**Planning Commission Agenda
Regular Meeting
Fort Lupton City Hall – 130 S. McKinley Ave.*
Thursday, June 9, 2022
6:00 P.M.**

- a. **P2022-012 The Flats at Lupton Village Change of Zone**
- b. **P2022-013 The Flats at Lupton Village Preliminary Plat and Preliminary PUD Plan**
- c. **P2022-014 Champion Xpress Car Wash Special Use Permit**

The Flats at Lupton Village
Construction Documents
Overall Utility Plan

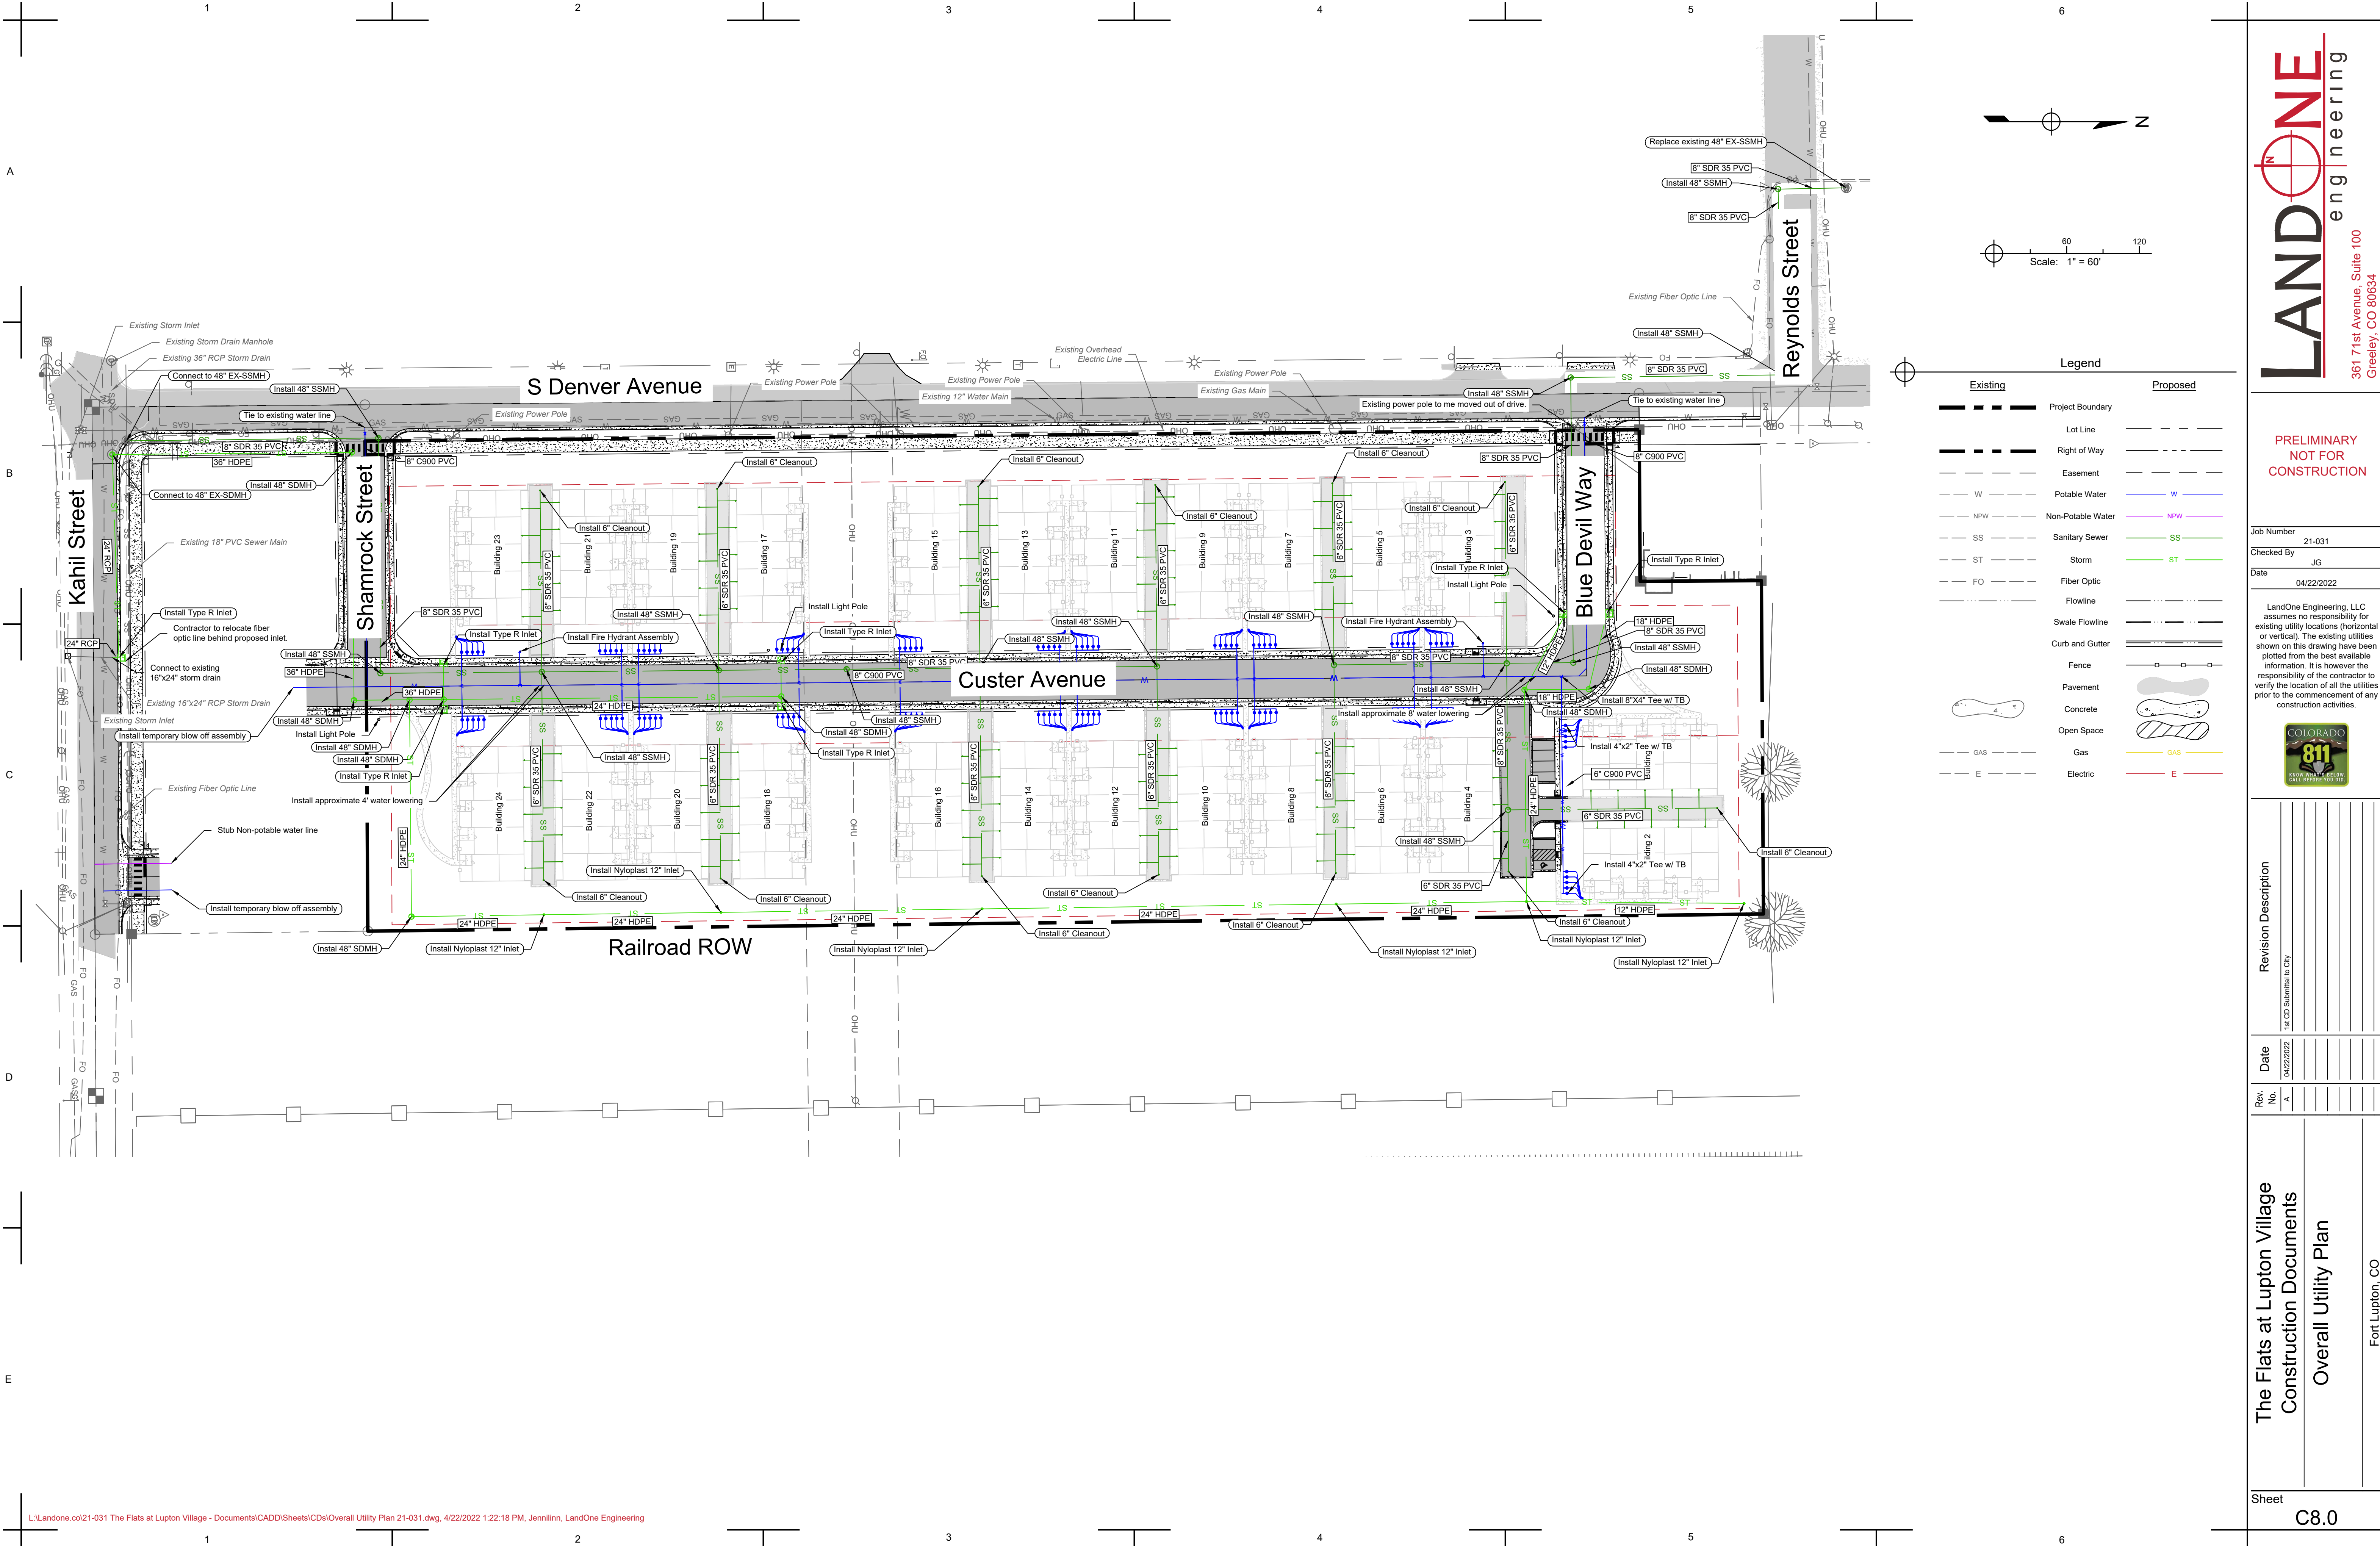
- i. Sheet C13.4 - The existing storm drain in Kahil is not accurately depicted. The inlets on the south side cross Kahil and connect to the storm sewer along the north side. Sheet C8.0 correctly shows the existing storm sewer along Kahil.
- ii.

The Flats at Lupton Village
Construction Documents
Potable Water Plan and Profile
Fort Lupton, CO

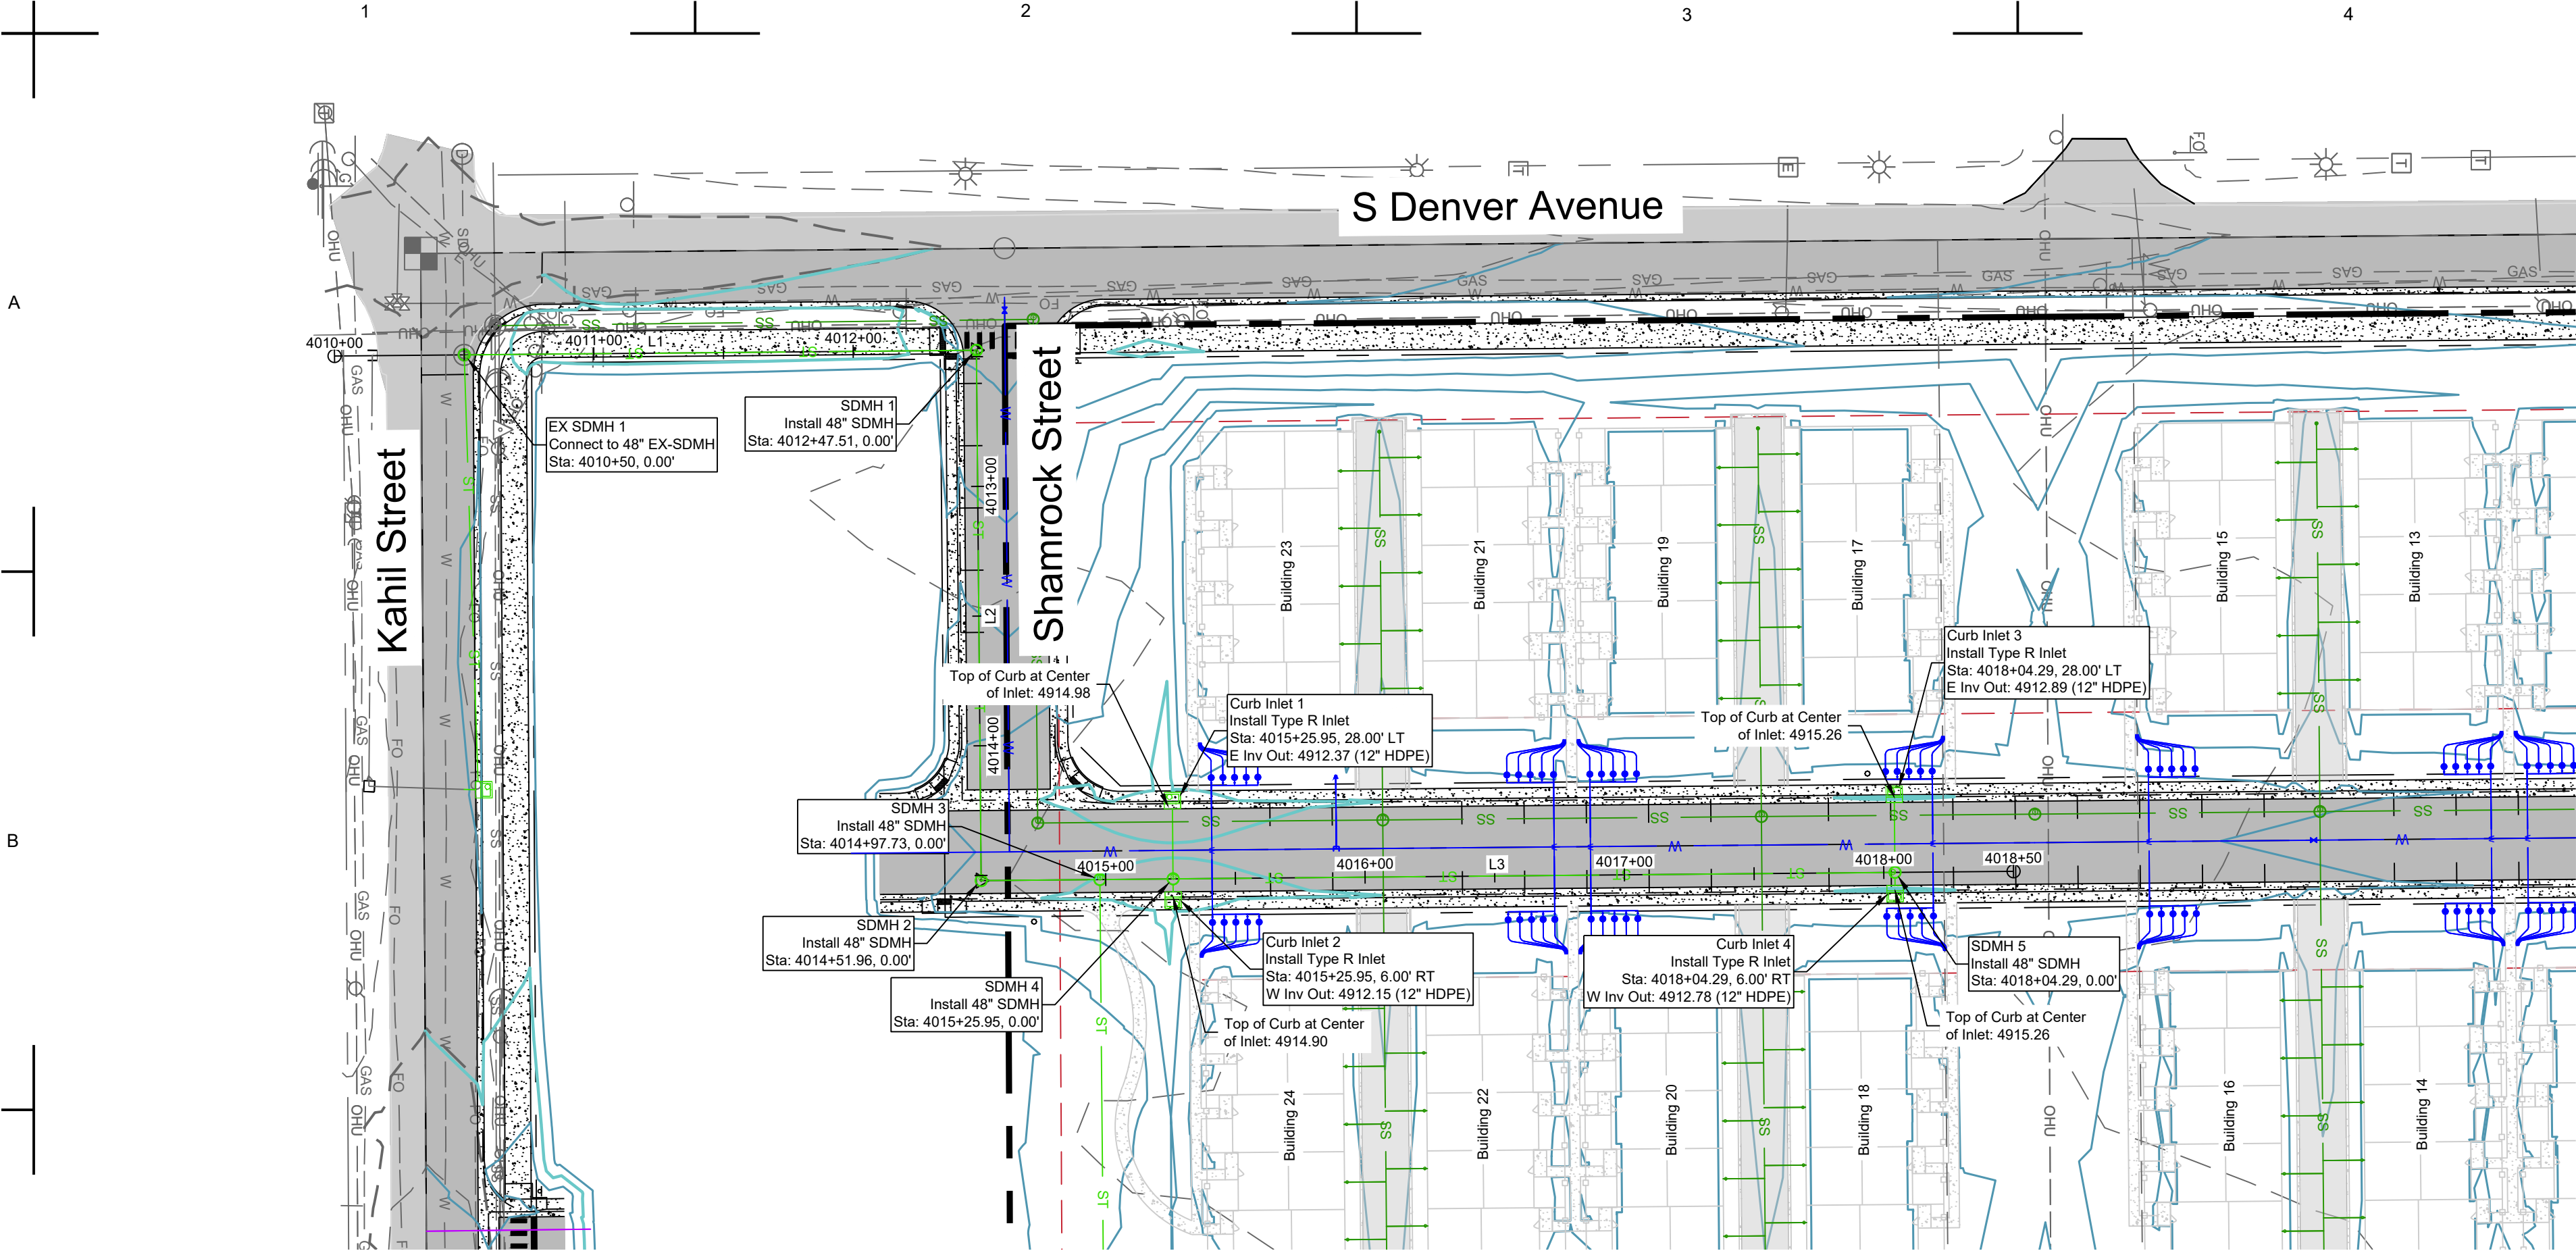
- i. City water main is located in S Denver Avenue.
- ii. Sheet 8 - Shows potable line connecting to the nonpotable water main.
- iii. **3.18.04 Sanitary Sewer Line Crossing Over A Waterline**
In all cases, regardless of vertical clearance, the sanitary sewer shall be encased in concrete a minimum of nine feet on each side of the centerline of the crossing or polyvinyl chloride pressure pipe in accordance with American Water Works Association C900, pressure class 305 psi may be used. Sheets C9.1 and C9.2 - Designate sanitary sewer line at water line crossings as C900 pipe one solid stick of pipe centered on crossing.
- iv. Sheet C9.3 - 2" water service crossing shows as 15-feet deep?
